**CITY OF MERIDIAN
FINDINGS OF FACT, CONCLUSIONS OF LAW
AND DECISION & ORDER**

In the Matter of the Request for Annexation and Zoning of 25.76 acres of Land with a C-G Zoning District; Preliminary Plat Consisting of Two (2) Multi-Family Residential Building Lots and Six (6) Commercial Building Lots on 29.7 Acres of Land; and Conditional Use Permit for a Multi-Family Development Consisting of 396 Units on 15.94 Acres of Land in the Proposed C-G Zoning District for Eagle View Apartments, by Brighton Development, Inc. Case No(s). H-2021-0075

STAFF REPORT

SUBJECT: [H-2021-0075](#); [CR-2022-0001](#)
Rackham East – AZ, PP
Eagle View Apartments – CUP, ALT, CR

C. Landscape Plan – Preliminary Plat (date: 10/15/2021)

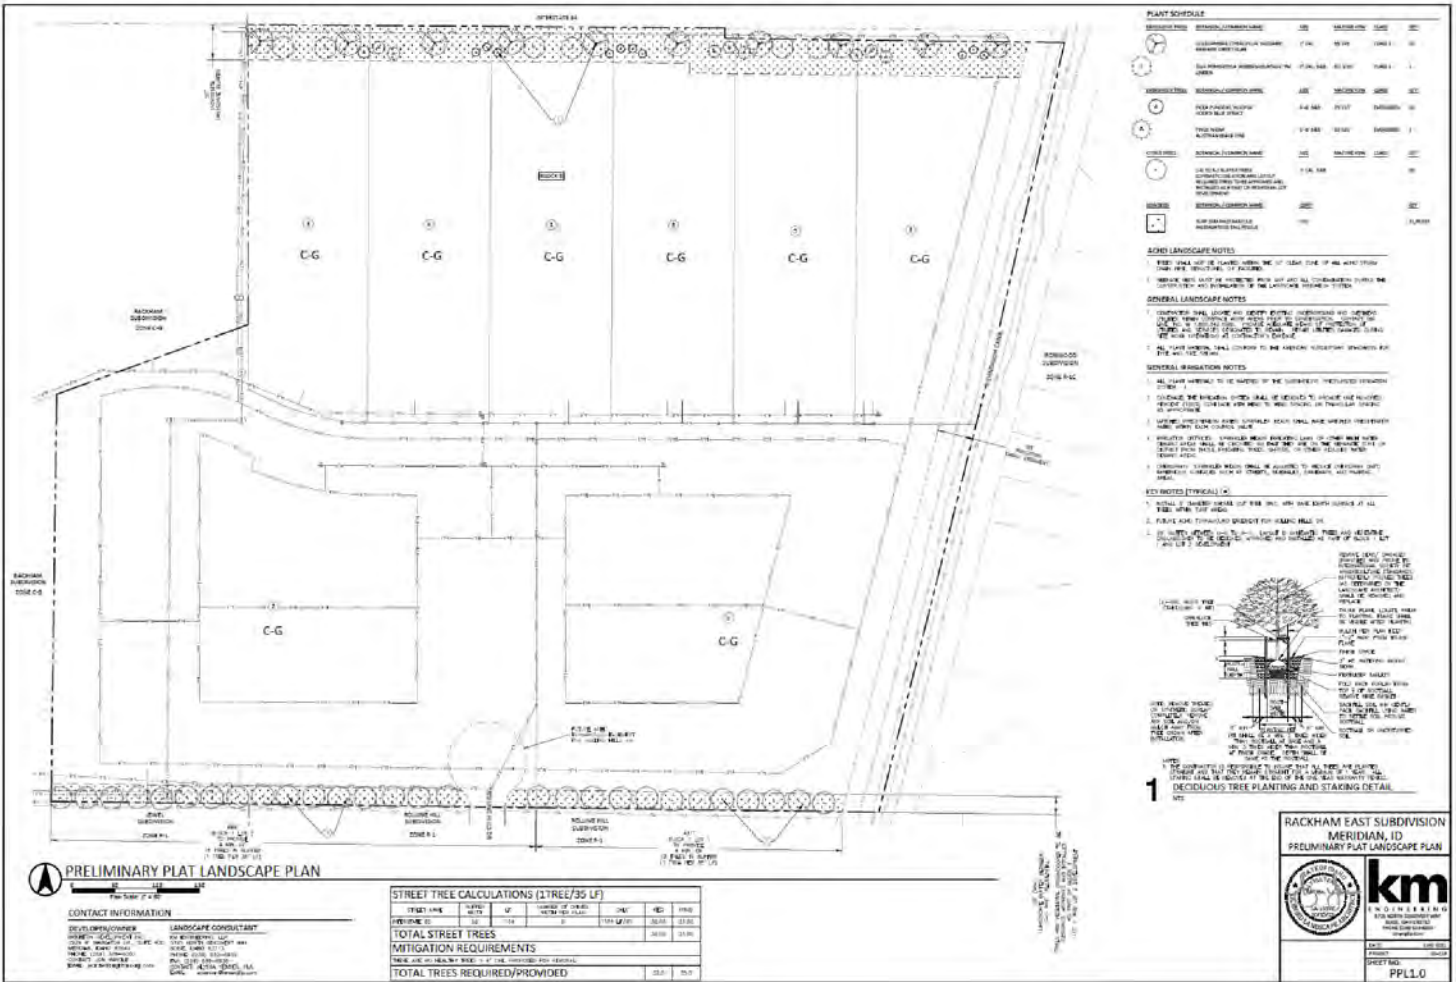
A 50-foot wide street buffer is required on Lots 3-6 along the north boundary of the site adjacent to I-84 per UDC [Table 11-2B-3](#), landscaped per the standards listed in UDC [11-3B-7C](#). The buffer depicted on the landscape plan complies with this standard. The street buffer is required to be maintained by the property owner or business owners' association per UDC [11-3B-7C.2b](#) and should be depicted on the plat in a common lot or permanent dedicated buffer.

Landscaping is required adjacent to the pathway proposed along the northern boundary of the site in accord with the standards listed in UDC [11-3B-12C](#). **A 5-foot wide landscape strip is required on both sides of the pathway planted with a mix of trees, shrubs, lawn and/or other vegetative ground cover.**

3. The landscape plan submitted with the final plat shall be revised as follows:
 - a. Depict a pathway within the street buffer along I-84 as shown on the CUP landscape plan with landscaping in accord with the standards listed in UDC 11-3B-12C. *A 5-foot wide landscape strip is required on both sides of the pathway planted with a mix of trees, shrubs, lawn and/or other vegetative ground cover.*

D. Conceptual Development Plan

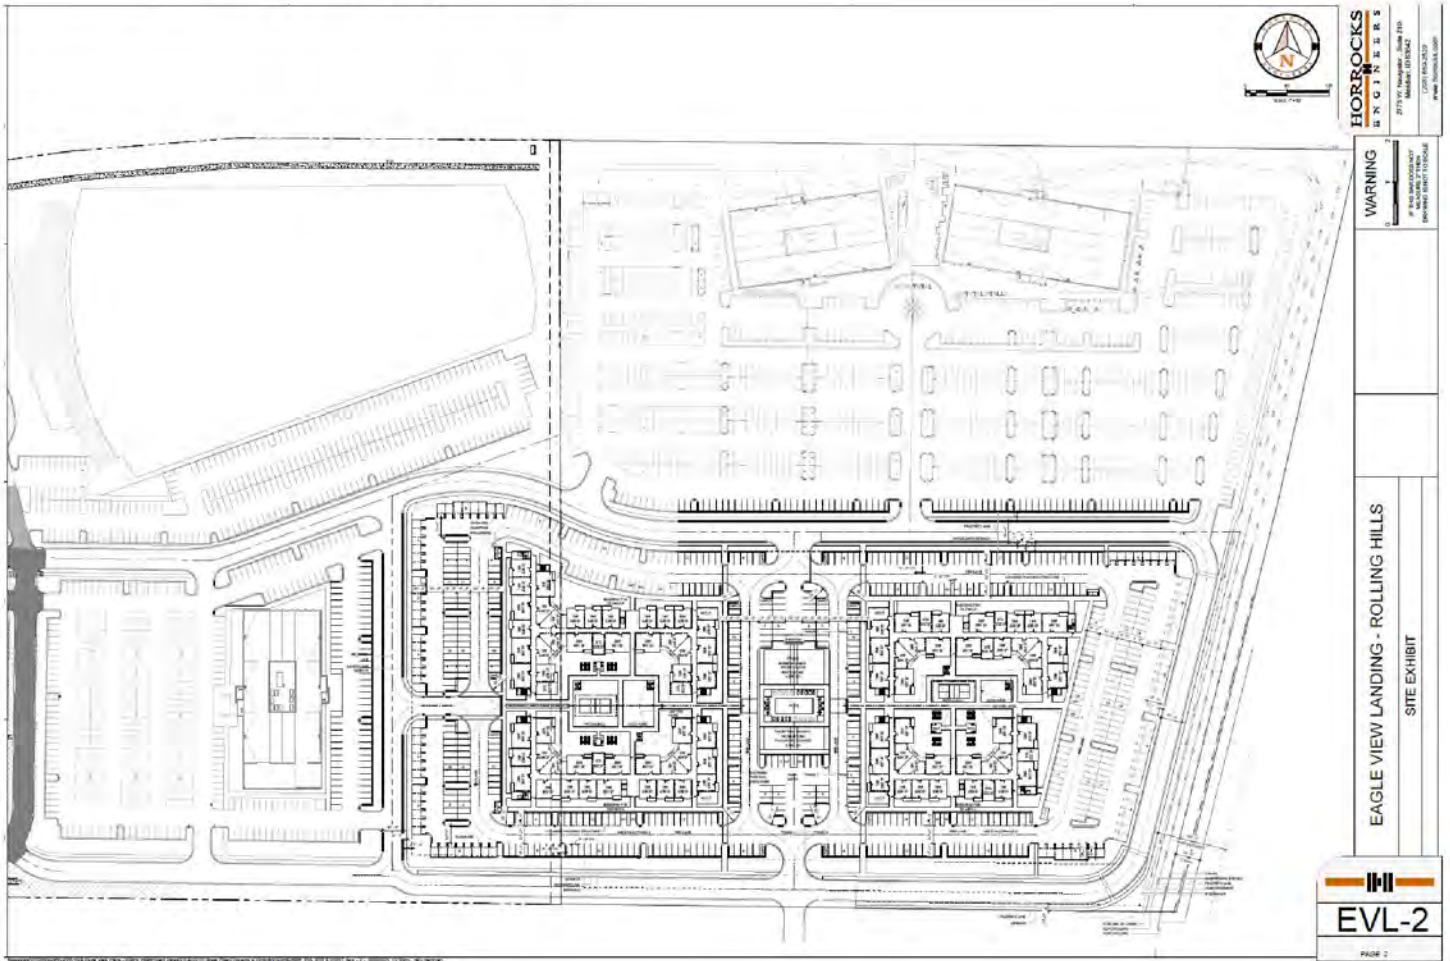
The conceptual development plan depicts a common area between the two office buildings that appears to meet this guideline; more details should be submitted on a site plan submitted for development of these buildings that comply with this guideline.

An outdoor gathering area is depicted on the conceptual development plan between the two office buildings on the northern portion of the site. Details should be submitted with development of these buildings that demonstrate compliance with this guideline.

The proposed conceptual development plan depicts a plaza/gathering area between the two office buildings on the northern portion of the site. A pedestrian circulation network, which will connect to the larger 90-acre Eagle View/Rackham development to the west, is proposed around the perimeter of the overall development as well as throughout the site that provide pedestrian connections to the multi-family development, office, retail, restaurant and hospitality uses within the development.

- b. The two (2) office buildings proposed on the northern portion of the site shall be arranged to create some form of common, usable gathering area, such as a plaza or green space in accord with the mixed-use guidelines in the *Comprehensive Plan* (see pg. 3-13).

E. Site Plan – Conditional Use Permit (dated: 6/3/21 1/6/22) & Phasing Plan

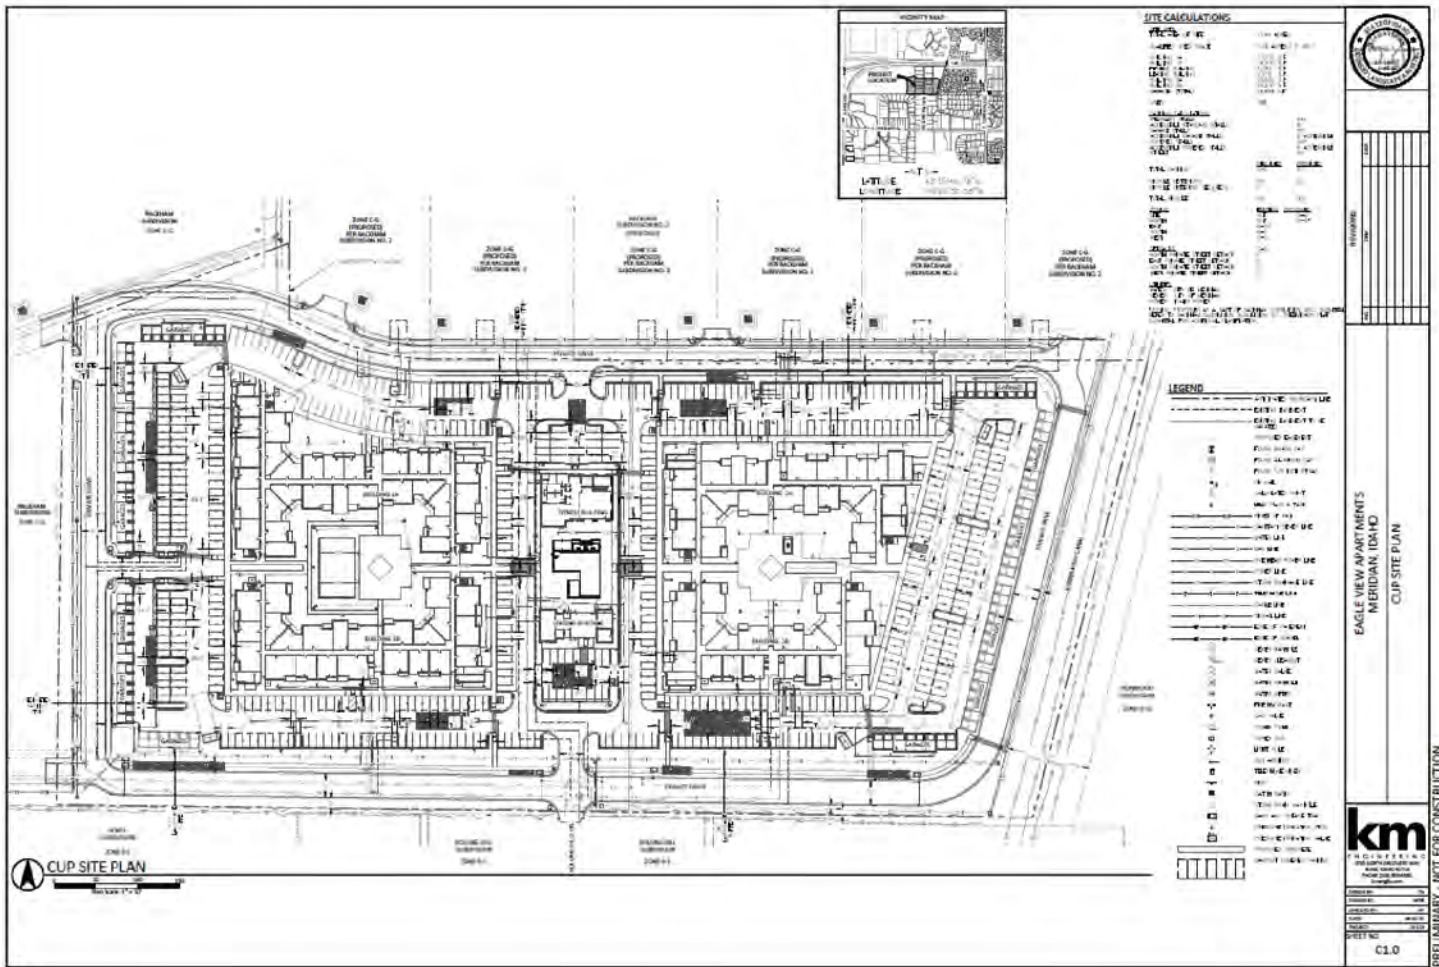
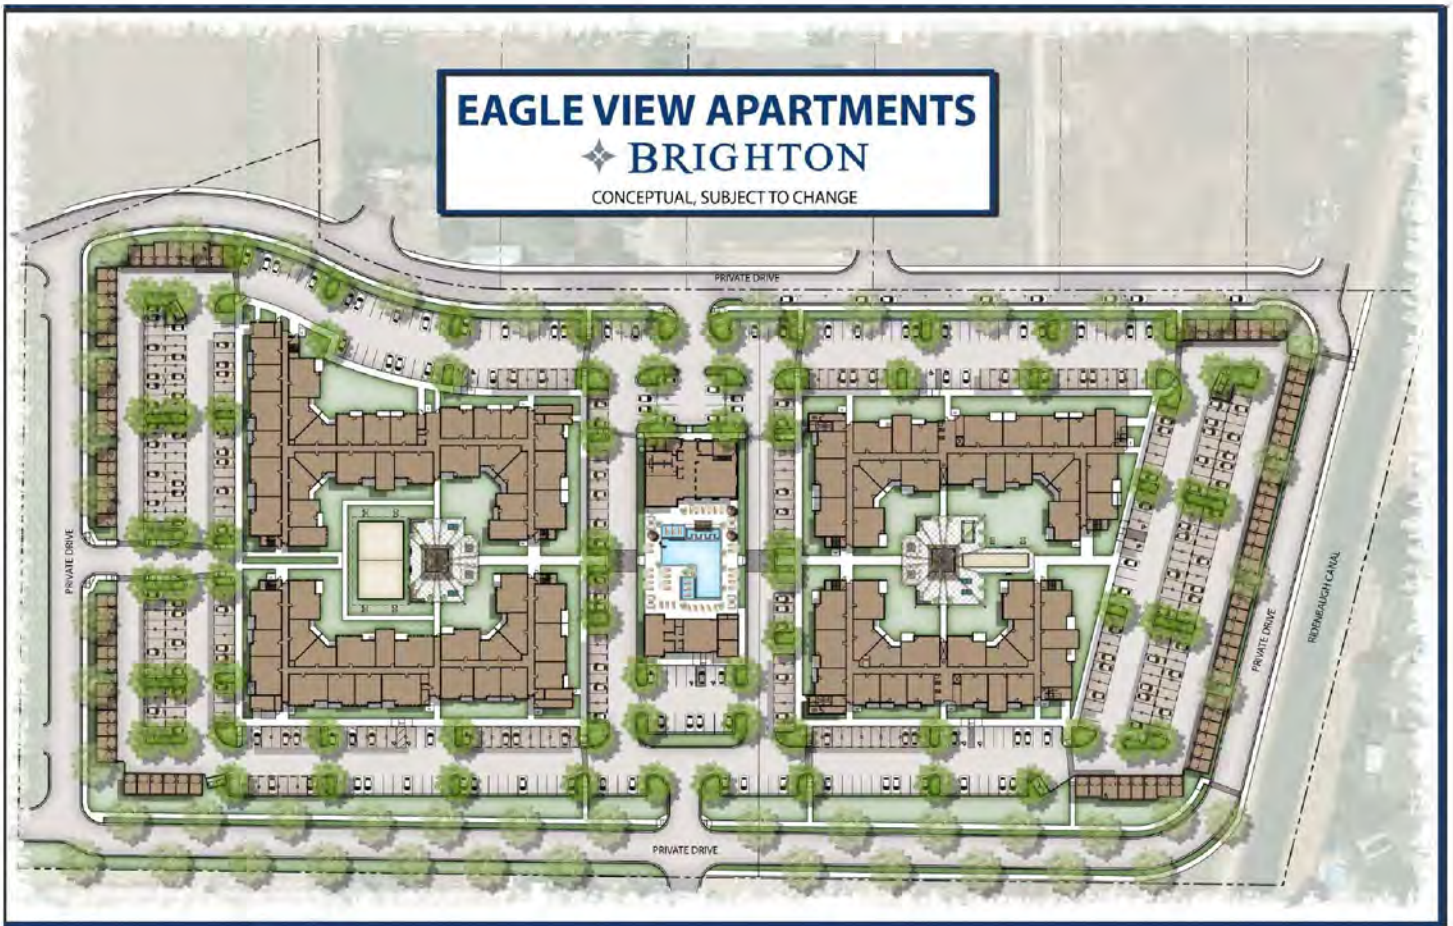
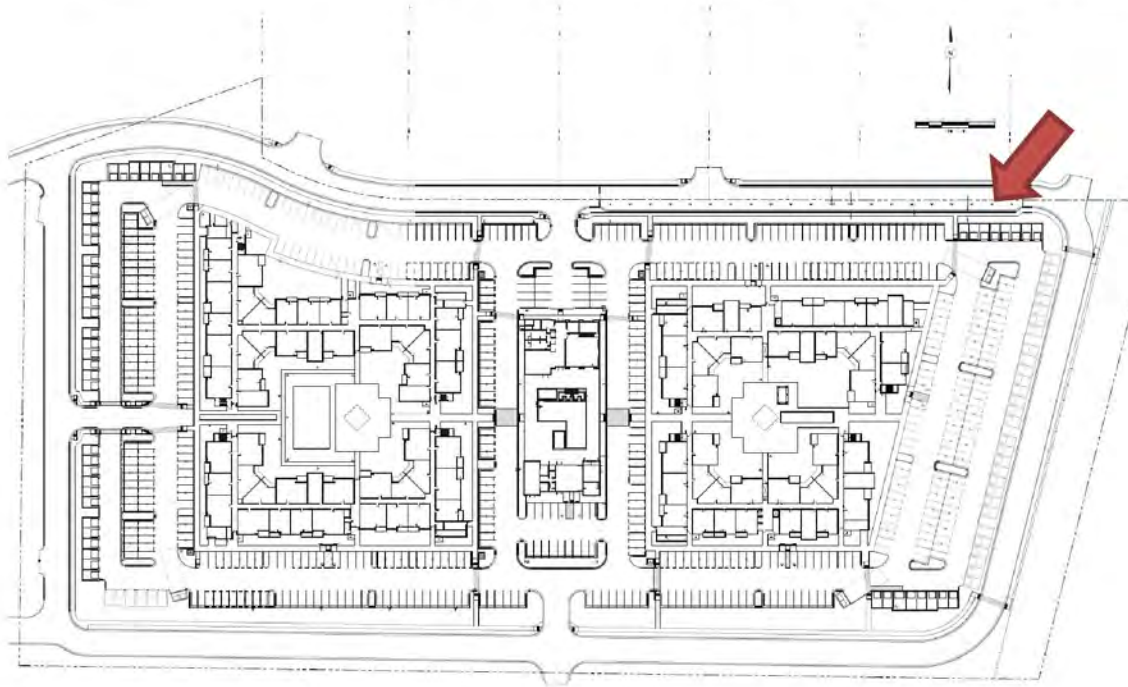
1. Buildings shall provide a minimum setback of ten feet (10') unless a greater setback is otherwise required by this title and/or [title 10](#) of this Code. Building setbacks shall take into account windows, entrances, porches and patios, and how they impact adjacent properties. *Staff is unable to determine if the buildings depicted on the concept plan meet the minimum setback standard. The site plan submitted with the Certificate of Zoning Compliance application should clearly depict the property lines in order to determine compliance with this standard.*

2. All on-site service areas, outdoor storage areas, waste storage, disposal facilities, and transformer and utility vaults shall be located in an area not visible from a public street, or shall be fully screened from view from a public street. *The plans submitted with the Certificate of Zoning Compliance application should demonstrate compliance with this standard.*

These items should be depicted on the site plan submitted with the Certificate of Zoning Compliance application.

A total of ~~651~~ 651 off-street spaces are proposed on-site with ~~391~~ 398 of those being covered in garages (88 90)/carports (303 308); another 20 on-street spaces are proposed on the updated site plan along the future private street along the north boundary – these spaces can serve as guest parking but do not count toward the “off-street” parking requirement, ~~which includes compact spaces; compact stalls are discouraged but may be used for parking above the number of required parking spaces.~~ **Additional parking (5 spaces) should be provided to meet the minimum standards; the site/landscape plan submitted with the Certificate of Zoning Compliance application should be revised to reflect compliance.** *Note: The calculations on the landscape plan state 651 spaces are proposed, which differs from that on the site plan.*

- d. Depict the location of the property management office; maintenance storage area; central mailbox location, including provisions for parcel mail, that provide safe pedestrian and/or vehicular access; and a directory and map of the development at an entrance or convenient location for those entering the development in accord with UDC [11-4-3-27B.7](#).

- e. Depict a 6-foot tall sight obscuring fence or wall along the southern boundary of the site as an added buffer to the rural residential properties to the south in Rolling Hill Subdivision.

F. Landscape Plan – Conditional Use Permit (dated: 6/3/21)

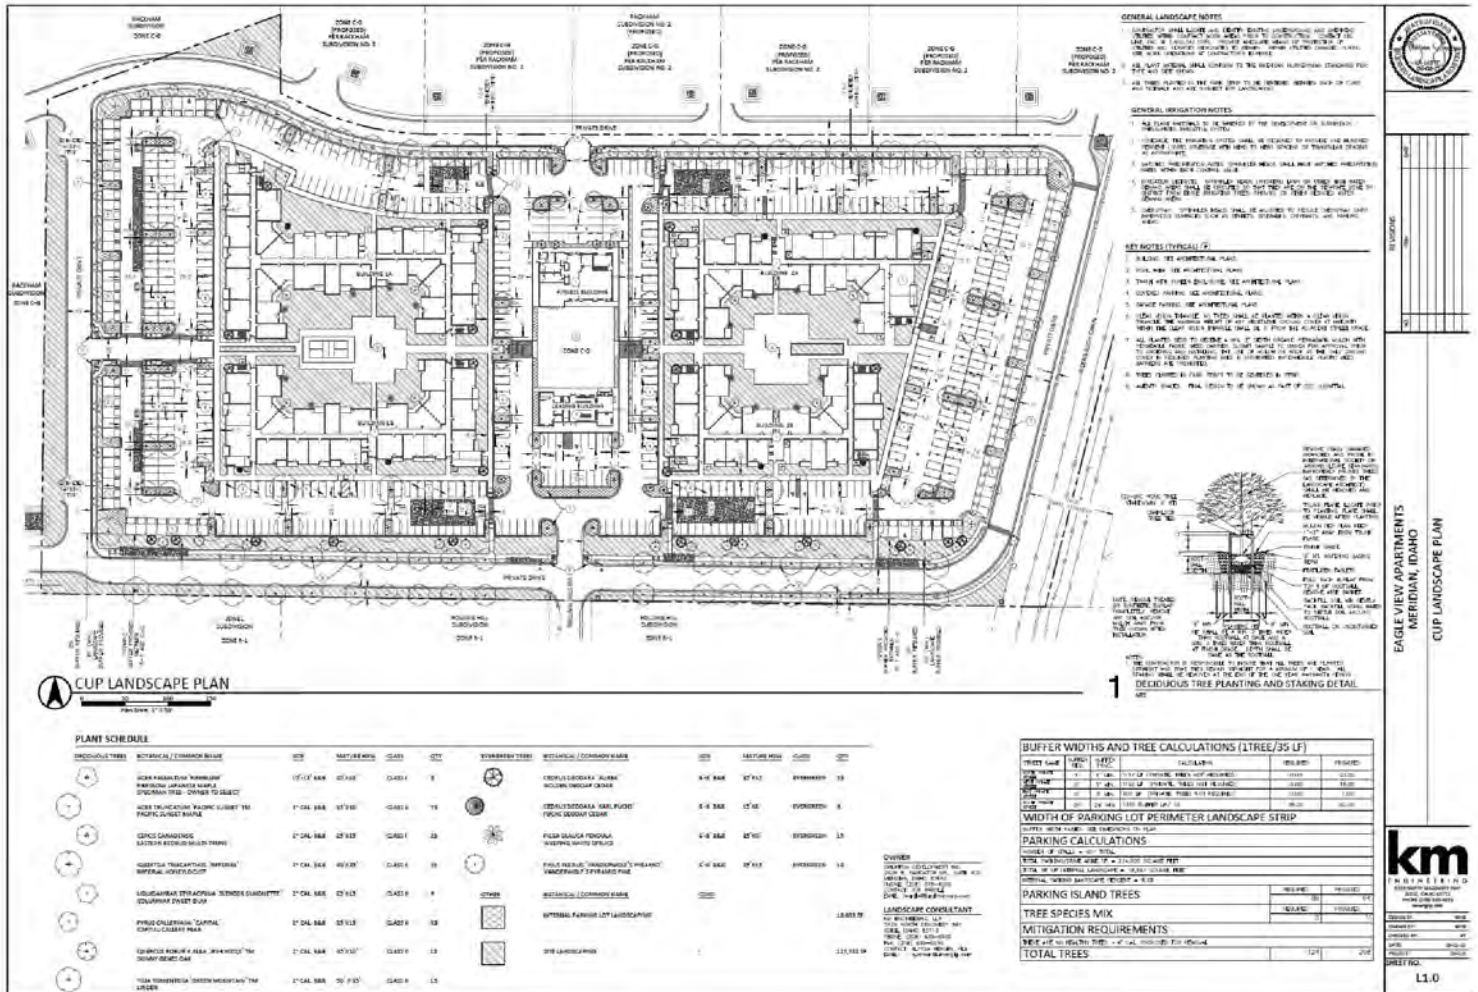
The landscape plan submitted with the Certificate of Zoning Compliance application should depict landscaping on all elevations facing the private drives in accord with these standards.

A minimum 25-foot wide buffer to residential uses is required with development along the southern boundary of the site per UDC Table 11-2B-3, landscaped per the standards in UDC 11-3B-9C, which requires a mix of evergreen and deciduous trees, shrubs, lawn, or other vegetative ground cover. **The buffer depicted on the landscape plan needs to be widened and additional landscaping depicted in accord with these standards.**

Fencing: No fencing is depicted on the landscape plan for this development. A 6-foot tall open vision wrought iron fence is proposed along the Ridenbaugh canal to preserve public safety if Council approves a waiver to allow the canal to remain open and not be piped.

As an added buffer to the two adjacent rural residential properties to the south in Rolling Hill Subdivision, Staff recommends a 6-foot tall sight obscuring fence or wall is constructed along the southern boundary of the site.

H. Pedestrian Circulation Plan

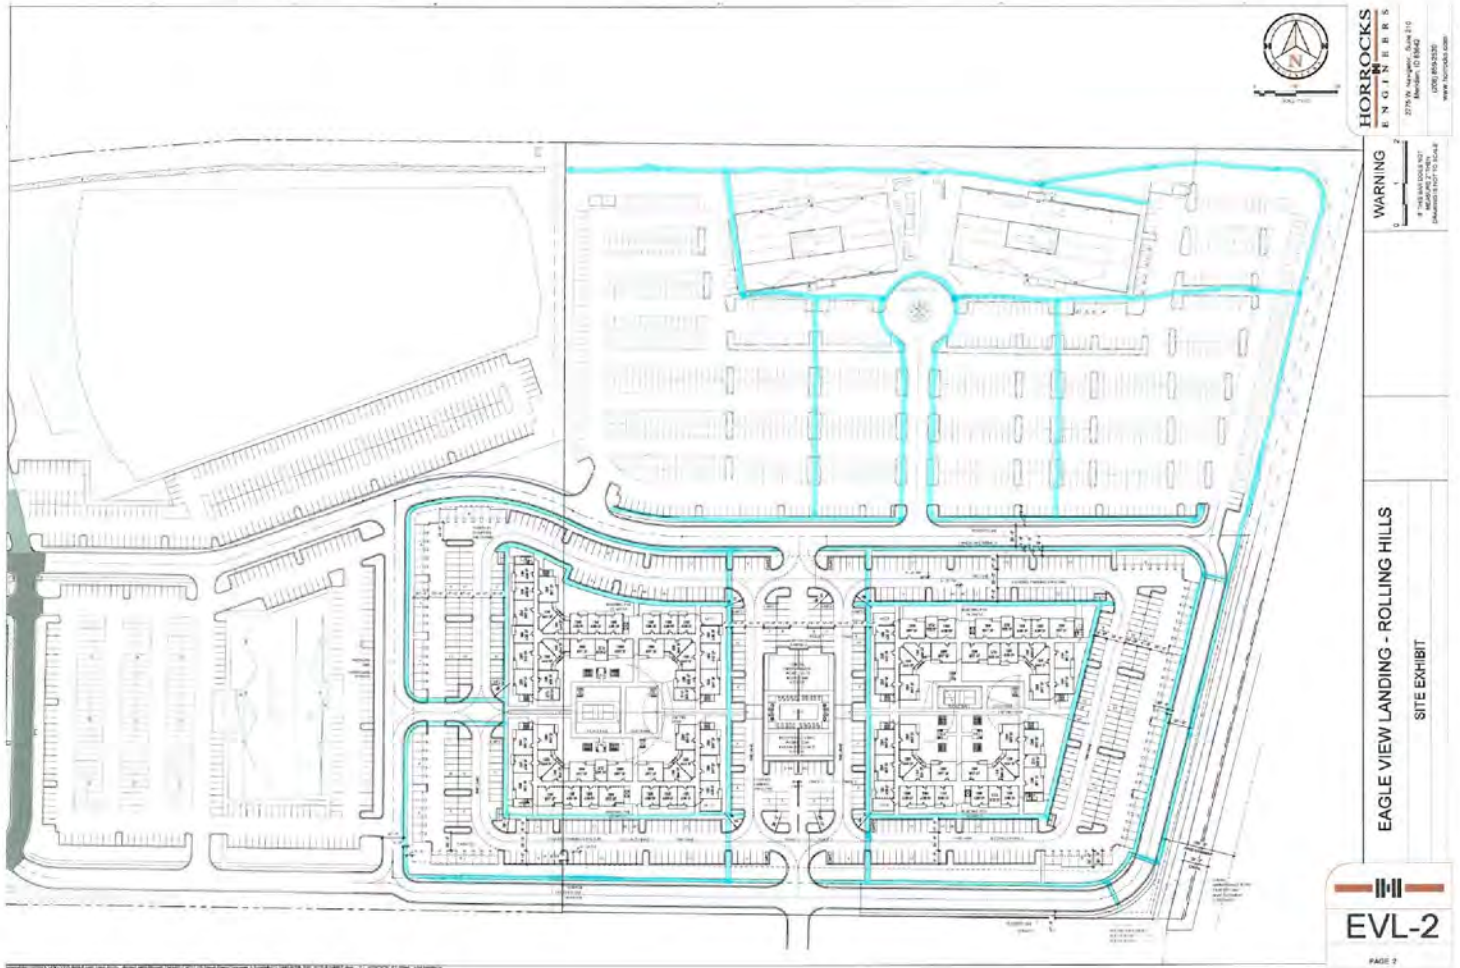
The conceptual development plan depicts a pathway within the street buffer along I-84. The pedestrian plan included in Section VII.H depicts internal pedestrian walkways throughout

There are no pathways depicted on the Pathways Master Plan for this site. **Staff recommends internal pedestrian walkways are provided throughout the site for interconnectivity; where pedestrian walkways cross vehicular use areas they should be distinguished through the use of pavers, colored or scored concrete, or bricks as set forth in UDC 11-3A-19B.4.**

- c. Provide a pedestrian pathway within the street buffer along I-84 as depicted on the conceptual development plan with landscaping along the pathway as set forth in UDC 11-3B-12C. Also provide internal pedestrian walkways throughout the site for interconnectivity; where pedestrian walkways cross vehicular use areas they shall be distinguished through the use of pavers, colored or scored concrete, or bricks as set forth in UDC 11-3A-19B.4.
